PROJECT NAME: FRANKLIN
PROJECT NUMBER: STP 030(18)

FILE NAME: /str/85c060/s85c060ww.dgn PLOT DATE: 21-MAR-2003
PROJECT LEADER: S. FARNSWORTH DRAWN BY: R. PELLETT
DESIGNED BY: M. FOWLER CHECKED BY: G. SPILAK
s060ww15282.1 SHEET 25 OF 60

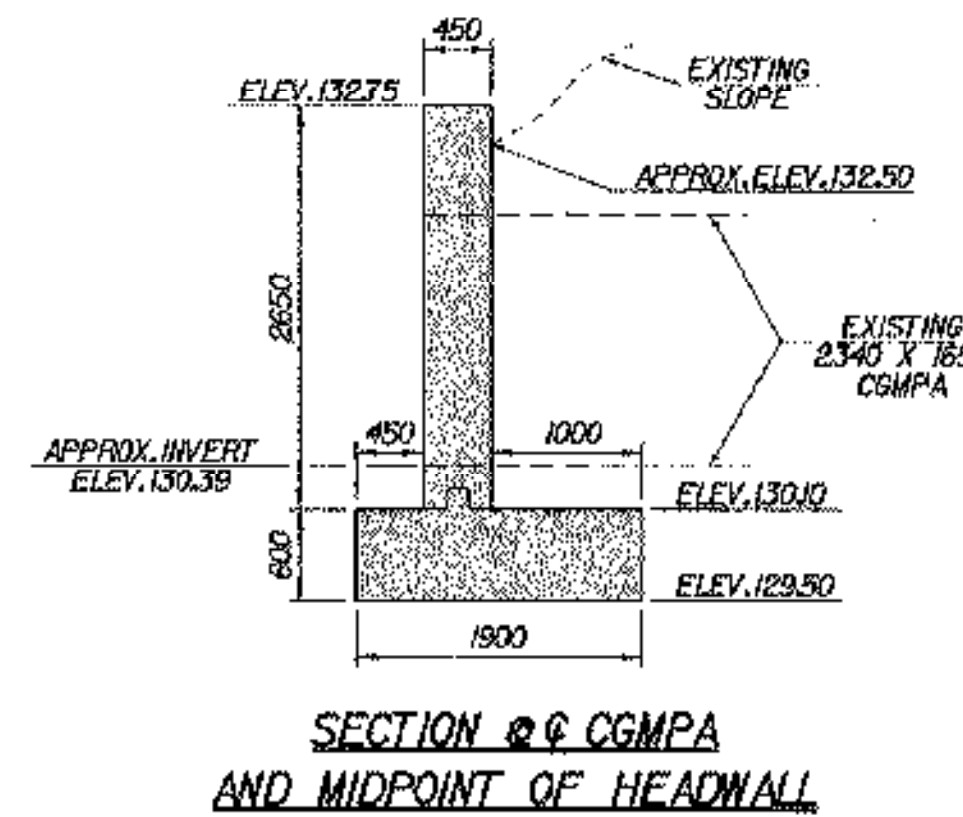
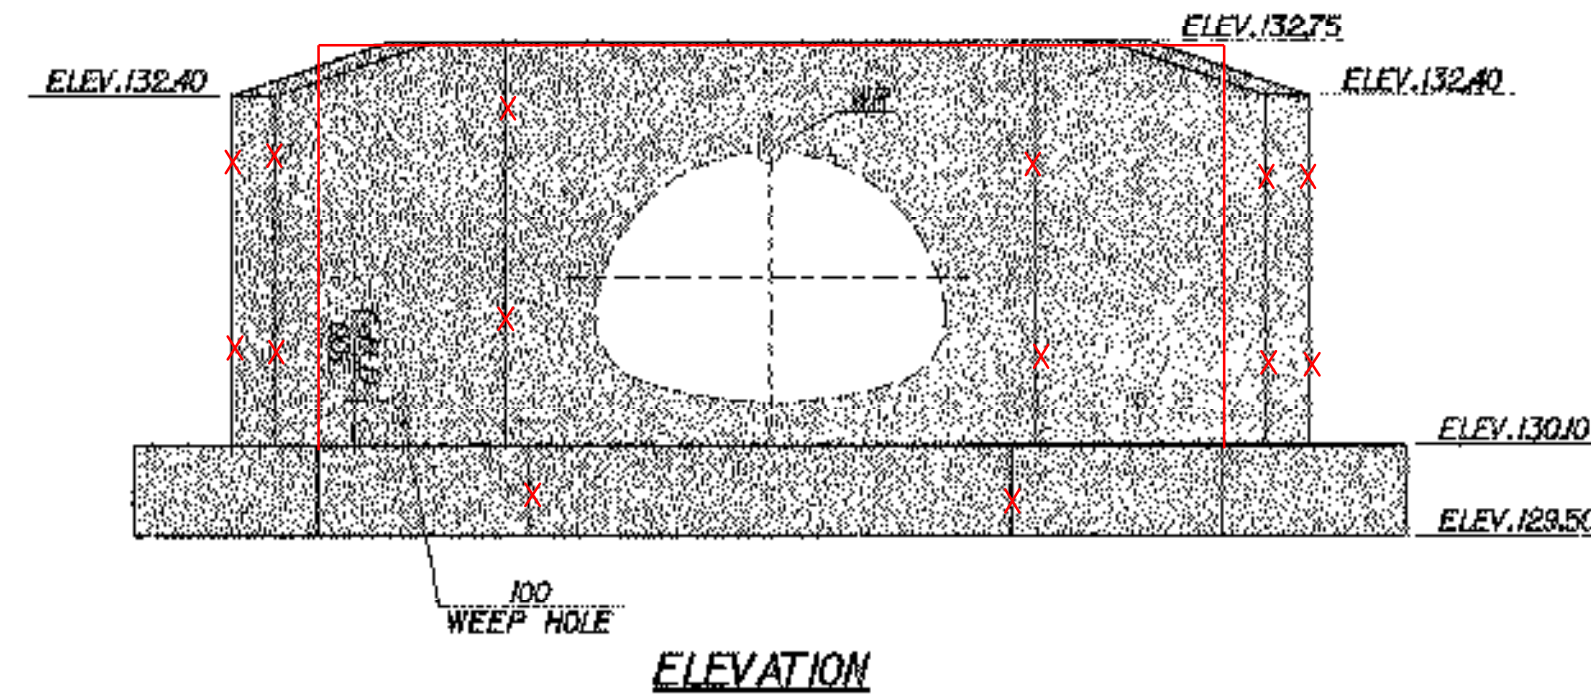
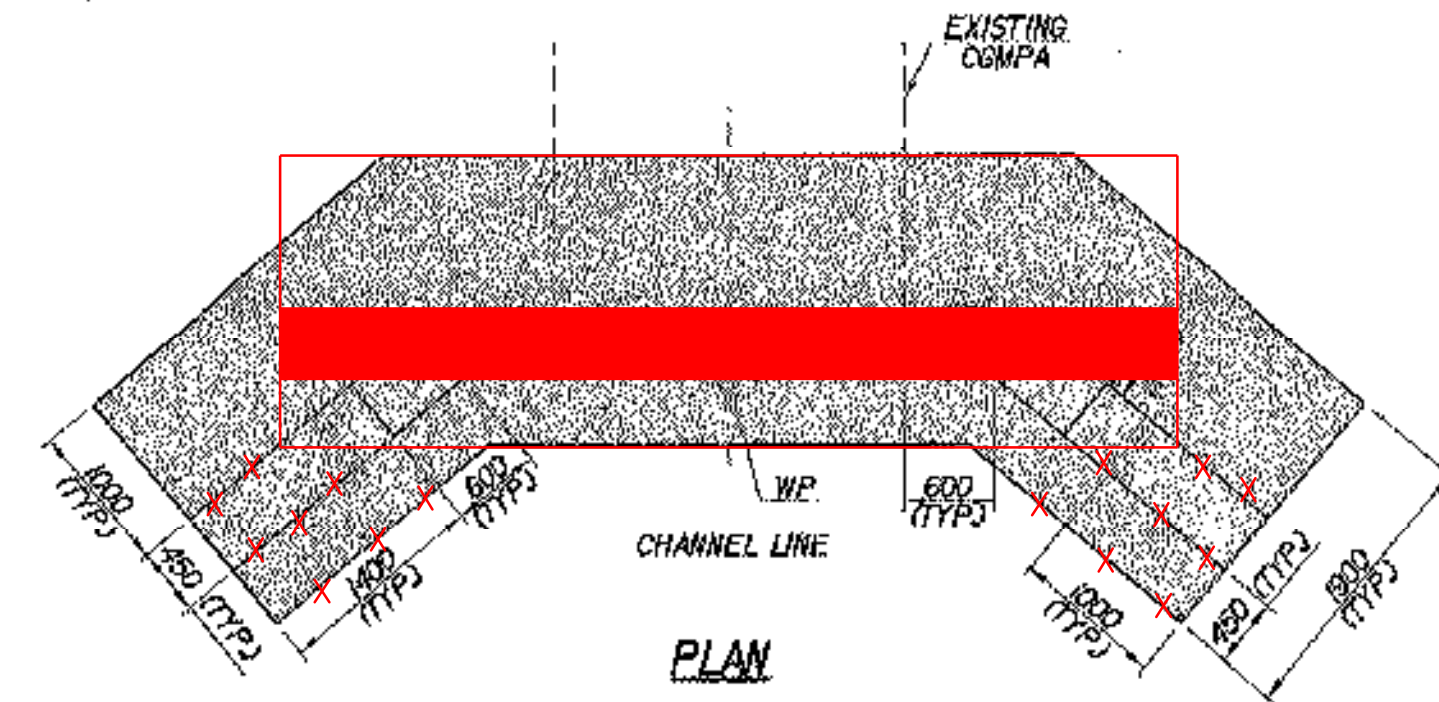
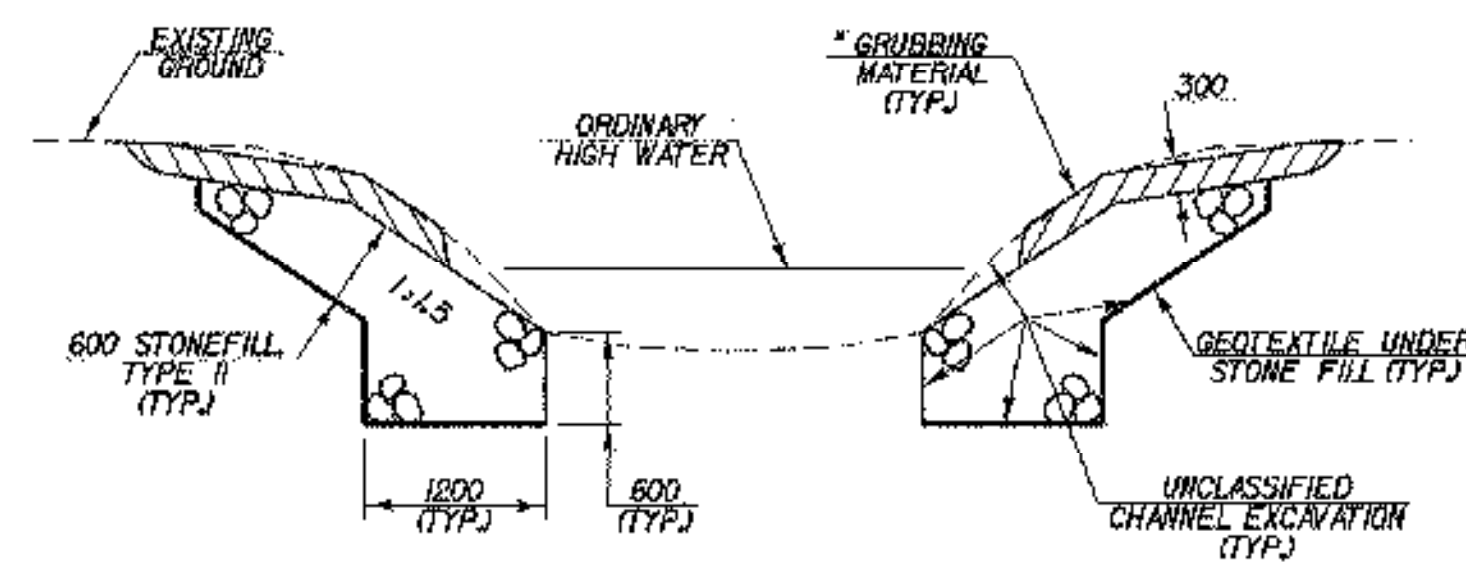
• CHANGE TO STRAIGHTEN HEADWALL
BECAUSE OF WATERLINE CONFLICT
